## **MEMORANDUM**

Informational Maps and Summary of Record Plats for the Planning Board

### PLAT NO. 220080710

#### Edgemoor

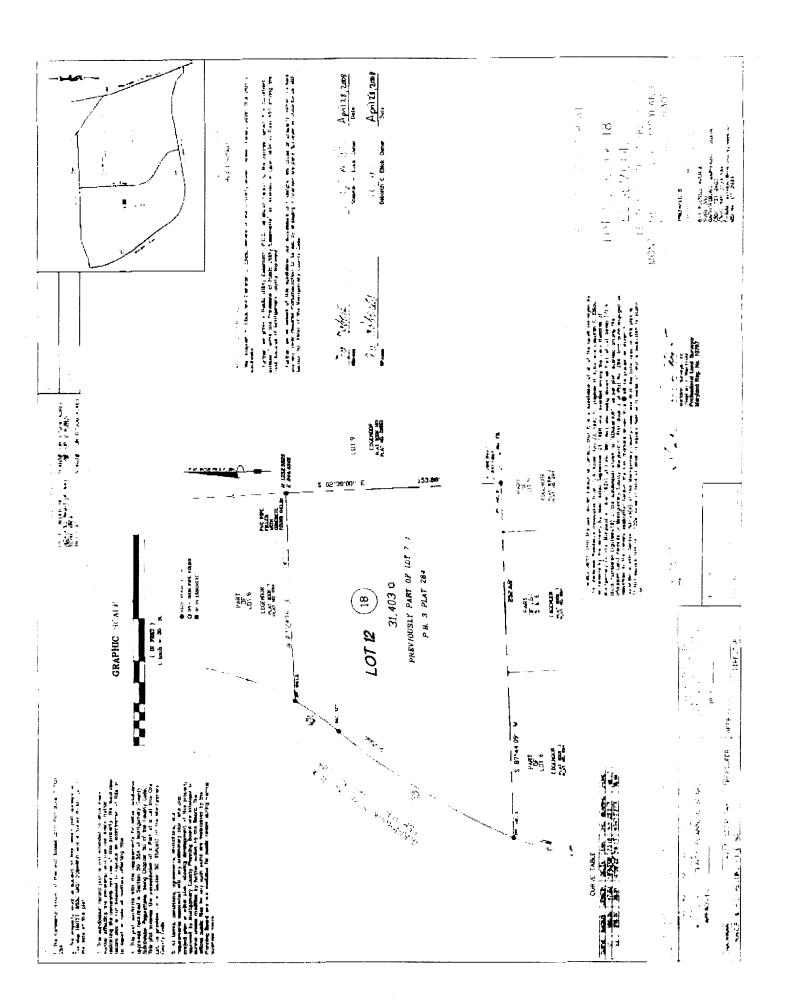
Staff recommends approval of this minor subdivision plat pursuant to Section 50-35A (a)(3) of the Subdivision Regulations, which states:

Staff applied the above-noted minor subdivision criteria for this property and concludes that the proposed subdivision complies with the requirements of Section 50-35A(a)(3) and supports this minor subdivision record plat.
